Appendix V

Public Comments Received on Public Review Draft SIP

Comments on the proposed revisions to the Washington State Implementation Plan for Regional Haze 11/23/2021

Figure 3. Wind Rose for Bellingham International Airport

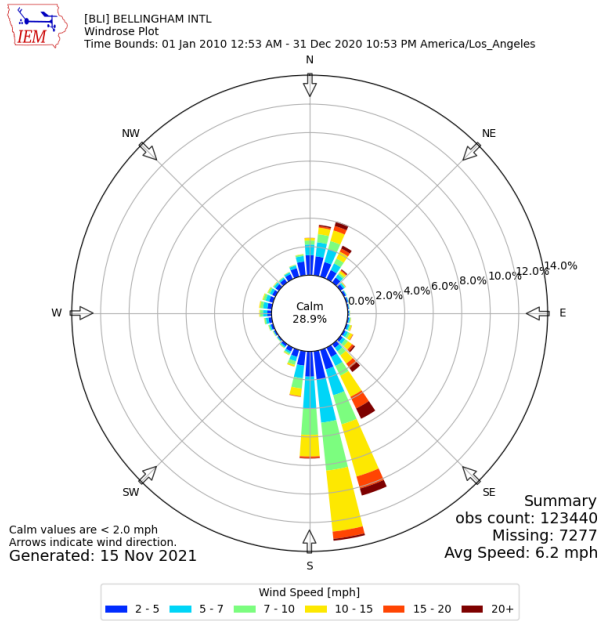
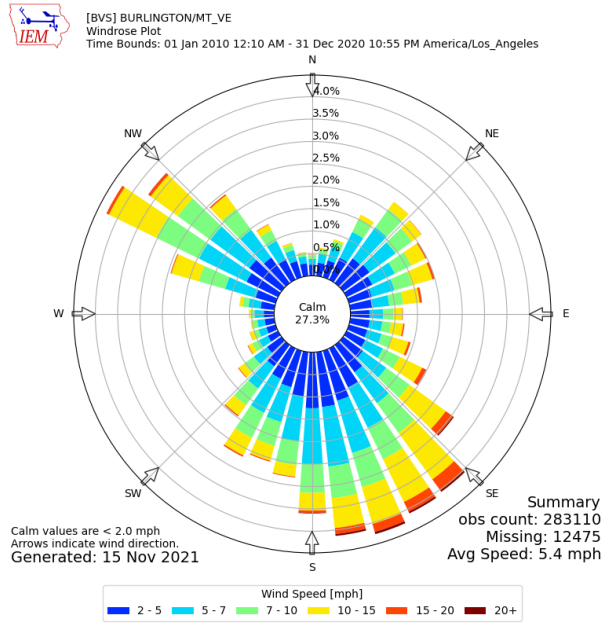
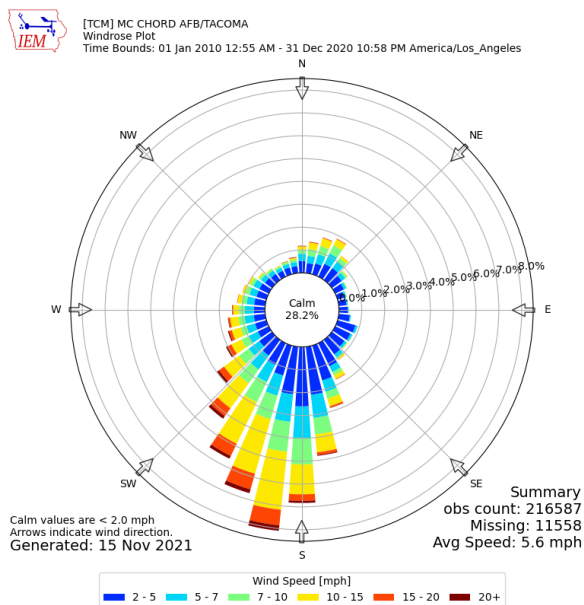
The wind roses in Figures 3 and 4 are for the Washington Automated Surface Observing Systems (ASOS) stations located nearest to the four refineries located on the north side of the state. As seen in both figures, the predominant winds in Bellingham are from the south to the north and the predominant winds at the Skagit Regional Airport are from the southeast to the northwest. In neither example do the wind roses indicate that winds would primarily travel from the refineries towards Washington's Class 1 areas, which are generally located to the east and southeast, with Olympic National Park farther to the southwest. A map of western Washington illustrating the locations of the refineries, wind roses, and Class 1 areas is provided in Attachment 2.

In the case of the final wind rose provided in Figure 5 below, the McChord Airforce Base ASOS station is the closest station to the U.S. Oil refinery located in Tacoma. As with the other wind roses, the predominant winds are not in the direction from the refinery towards the Class 1 areas, but rather from the south to the north. The predominant winds in all cases indicate emissions from refineries are infrequently travelling toward Class 1 areas. The limited expected impact of the U.S. Oil refinery in particular is further supported by the site's Q/d screening ratio of 3.21. The U.S. Oil refinery has a Q/d ratio of less than one third of the threshold used by Ecology for source selection. The screening results alone indicate that U.S. Oil does not have an expected impact on visibility impairment at Class 1 areas that warrants inclusion in the draft SIP.

WSPA therefore requests that Ecology remove the statement indicating that predominant winds direct refinery emissions towards Washington’s Class 1 areas (to the east or northwest). A suggested revision to this passage in the 2nd draft is provided in Attachment 1.

Figure 6. Capital Cost Comparison Between EPA Control Cost Manual and Revised SCAQMD Model (SCAQMD, 2021, red line annotation added)

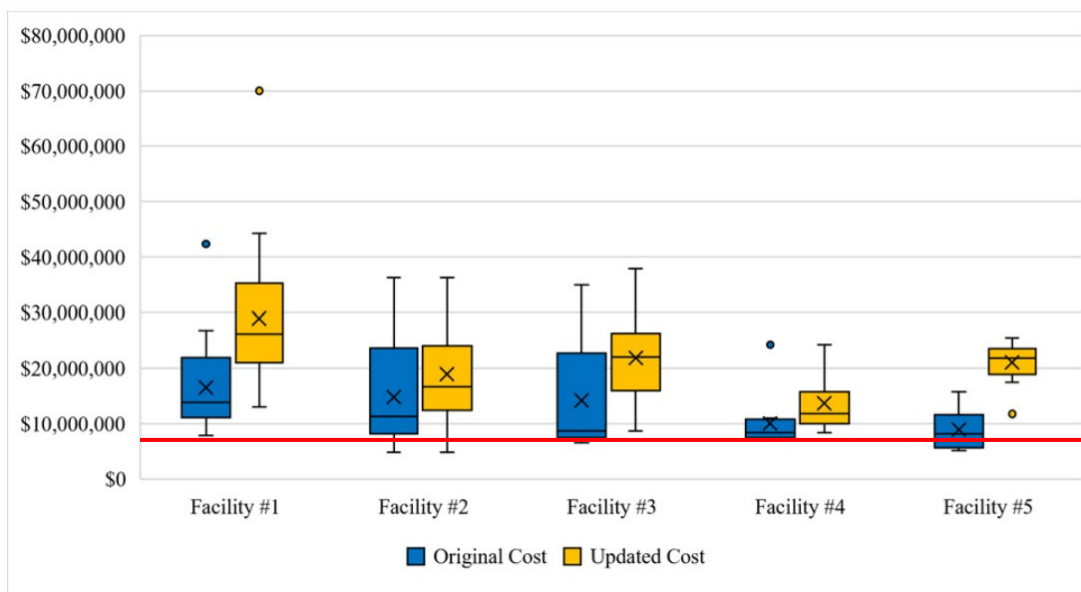
Ecology for each of the heaters and boilers considered in the 2nd draft SIP (\$6,750,635). As illustrated in the figure, Ecology's preliminary cost estimates are below even the SCAQMD initial estimates that used the existing EPA Control Cost Manual When compared to the refined costs using the revised model that was accepted by SCAQMD for the final rulemaking, the comparison shows that Ecology's preliminary cost estimates vastly under-estimated the actual costs of SCR implementation on refinery boilers and heaters.

WSPA recognizes that there are notable differences in circumstances between Southern California and Washington that will necessitate a deeper review of the revised cost model. The cost effectiveness values for the SCAQMD rulemaking are not directly comparable to the cost effectiveness values under regional haze because the two programs have different goals and also because the two programs use difference cost bases. The SCAQMD cost effectiveness values are determined using the discounted cash flow (DCF) method.⁸ The EPA Control Cost Manual, in contrast, uses the equivalent uniform annual cash flow (EUAC) approach.⁹ While the regulatory context for these costs is different and means the final cost effectiveness values are not directly comparable to those calculated for the Washington's Regional Haze program, the refined SCAQMD model's capital costs are appropriate to compare. The SCAQMD model and associated capital costs can serve as a helpful reference point for reasonable capital costs and a strong starting point for future cost calculation discussions.¹⁰

Figure 1 Components included in the EPA Cost Model Shown in Yellow. Components not included in the EPA Cost Model shown in Blue

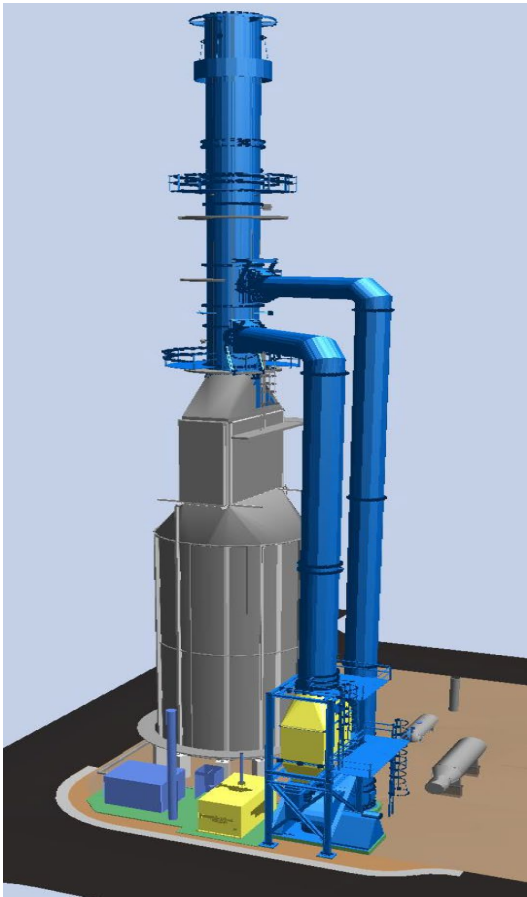
Figure 1 shows in yellow the equipment included in the EPA SCR Control Cost Model and shows in blue the ancillary equipment necessary for operation that is not included in EPA’s SCR Control Cost Model.

The EPA SCR Cost Model inappropriately excludes the following ancillary equipment that are required to be installed for proper SCR operation at a typical heater or boiler:

Therefore, Ecology should revise its draft RH SIP and consider in any future reasonableness assessment the real expected costs for retrofitting equipment, including the ancillary equipment costs required to operate SCR.

Figure 2 MPC's and Ecology's SCR Total Capital Costs Overlaid with Figure B-4 of the SCAQMD Rule 1109.1 Staff Report

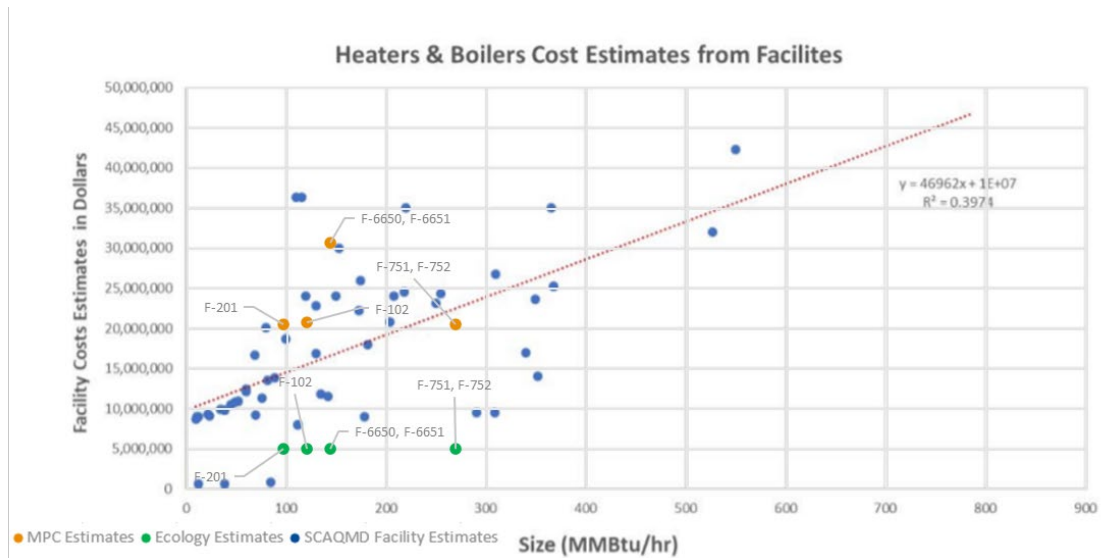
MPC's estimates (shown as orange dots) and Ecology's estimates (shown as green dots) on top of SCAQMD's distribution of estimated costs based on equipment size.⁶ As Figure 2 demonstrates, MPC's costs are consistent with SCAQMD's cost estimates, while Ecology's estimates fall well below the linear regression line of the data used by SCAQMD.

Importantly, SCAQMD ultimately acknowledged the limitations of the EPA Cost Model and developed their estimates of total capital costs for installation of SCR by considering actual facility costs of installation that were submitted by refineries, which were reviewed by third-party engineering firms (i.e., FERCo and Norton Engineering). SCAQMD even stated in its rulemaking Draft Staff Report that the “Total Installation Cost (TIC) for SCR installations in the refining sector can be up to 10 times more expensive due to the limited space within processing units; some facilities have performed elaborate SCR engineering designs to install their SCRs. As a result of space and engineering requirements, TIC cost that a refinery incurs increases significantly compared to the electric power generating sector.”⁷ To support its cost-effectiveness calculations for the RH SIP, Ecology should consider the approach used by SCAQMD for its Rule 1109.1. In doing so, Ecology should also incorporate the costs MPC provided in its 2020 FFA Report into the cost-effectiveness calculations in the RH SIP and any future reasonableness assessment.

Figure 4 Summary of Draft RH SIP's Representation of NO_x Emissions in Representative Baseline Year

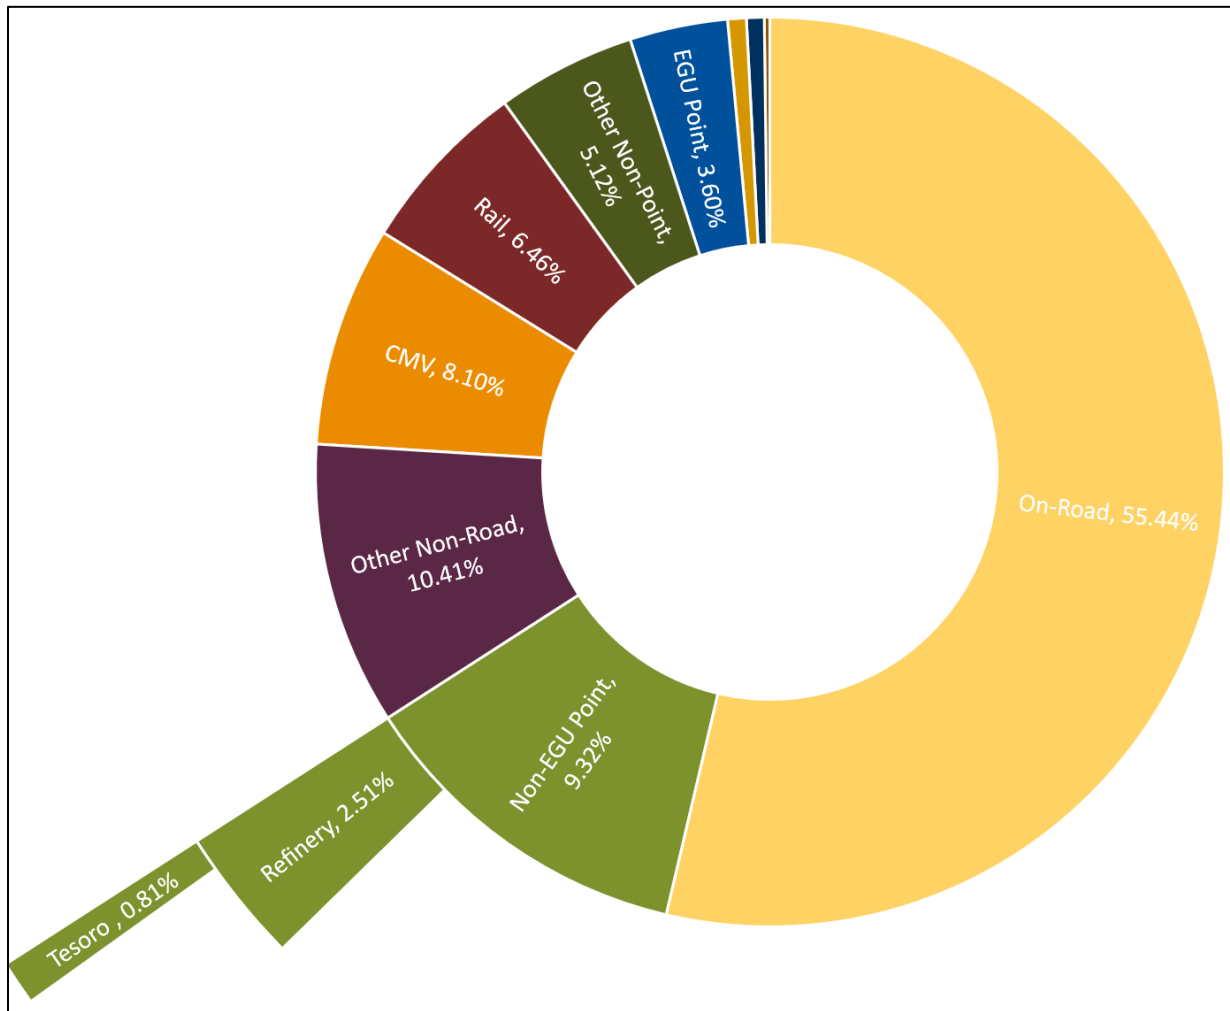
Additionally, refinery impacts on NO_x emissions are overstated in the draft RH SIP. Figure 6 summarizes Ecology's representations of NO_x emissions for the representative baseline year in the draft RH SIP.

Non-electrical generating unit (non-EGU) point sources, refineries, and MPC's Anacortes Refinery account for only 9.3%, 2.5%, and 0.8% of the NO_x emissions in the representative baseline year, respectively. Refinery NO_x emissions represent a small portion of the state emission inventory and are a minor contributor to light extinction. Focusing mainly on NO_x controls at refineries is not reasonable based on the minimum impact it would have on visibility, and modeling future cases already indicates results below the adjusted glide path.
